THE PORT AUTHORITY OF NY & NJ
PROCUREMENT DEPARTMENT
4 WORLD TRADE CENTER
150 GREENWICH STREET, 21ST FL.
NEW YORK, NY 10007

ADDENDUM # 6

To prospective Proposers on RFP # 55158 - Solar Photovoltaic (PV) Power Generating System on the Roof of the MacMillan Bloedel Building:

EXHIBIT 2D – ENLARGED PAGE 2 OF 3 (Part 1 of 2)

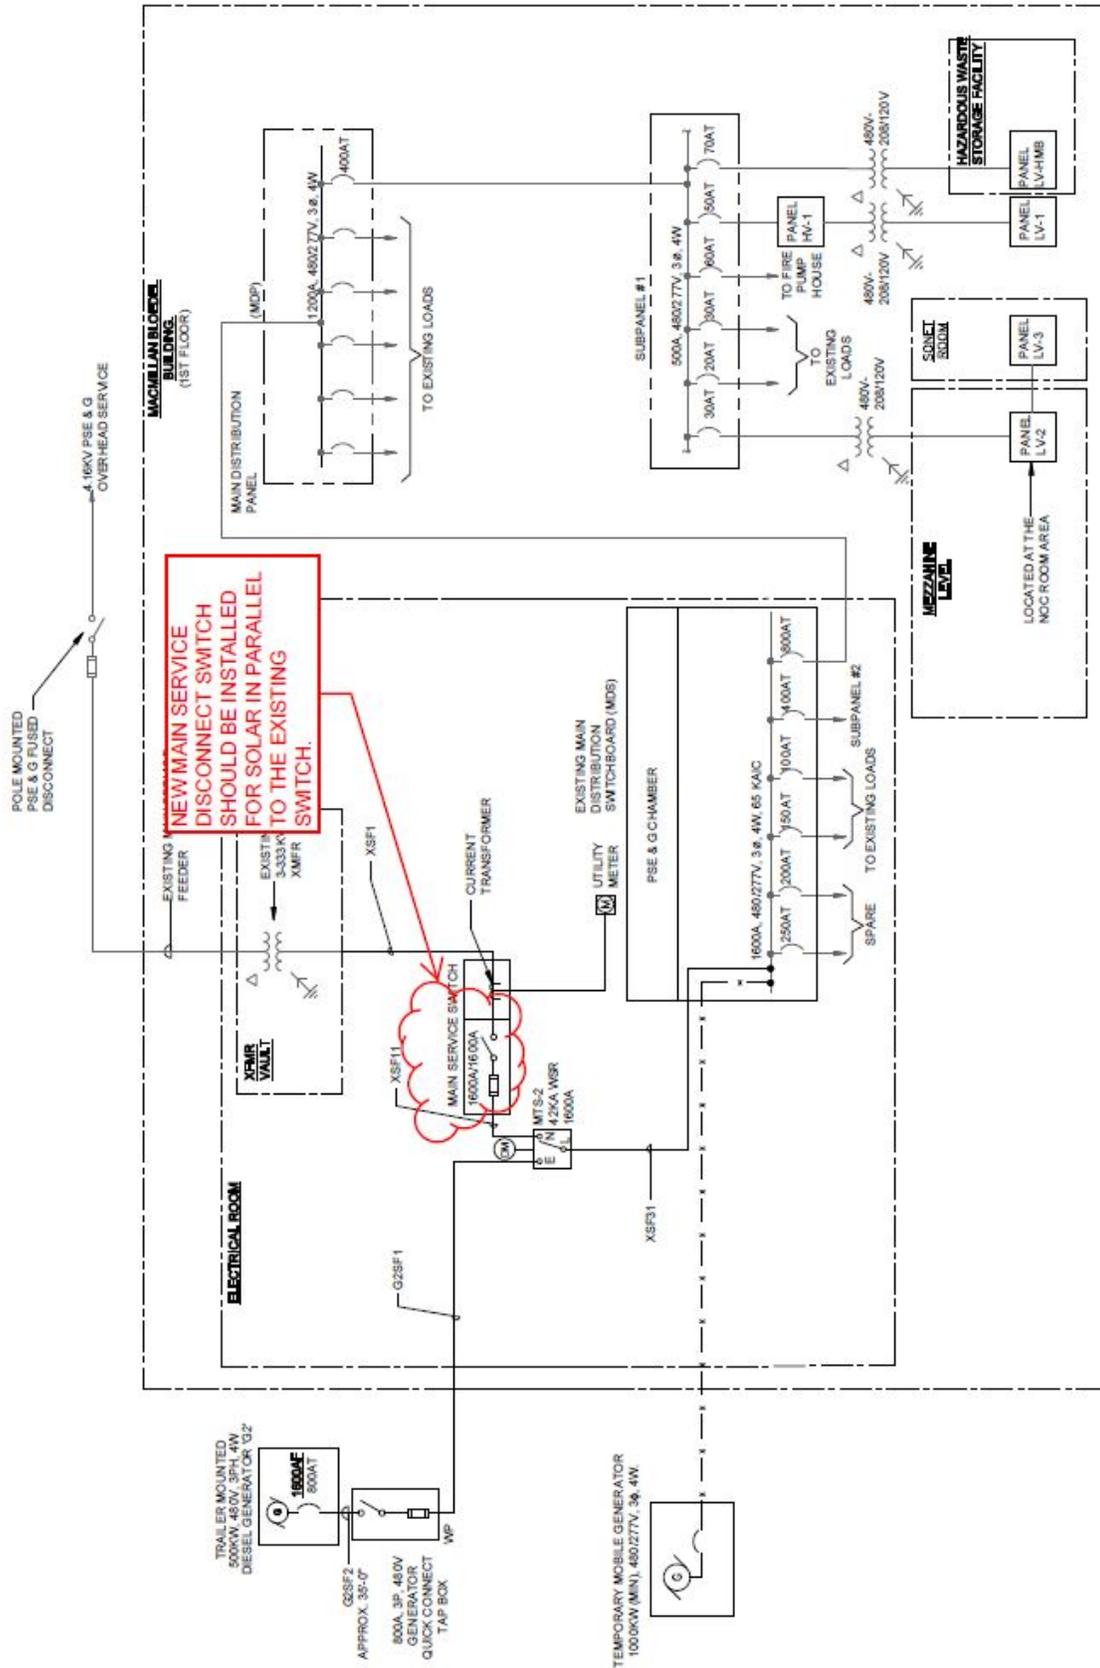
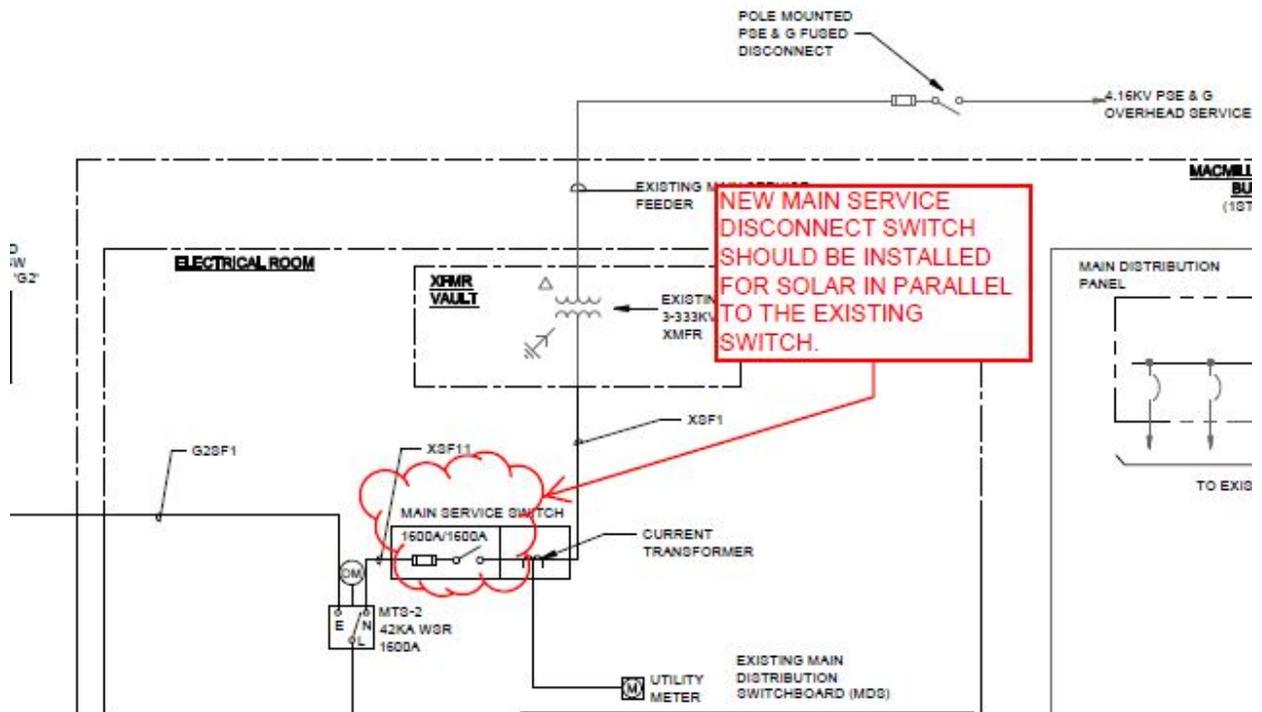
- B. Insert the attached five (5) pages after page 50 of the RFP, which is titled “Exhibit 2E – Historic KW and KWH Data.” The new pages are enlarged versions of the current drawings included on pages 48 and 49 and the table on page 50 of the RFP.
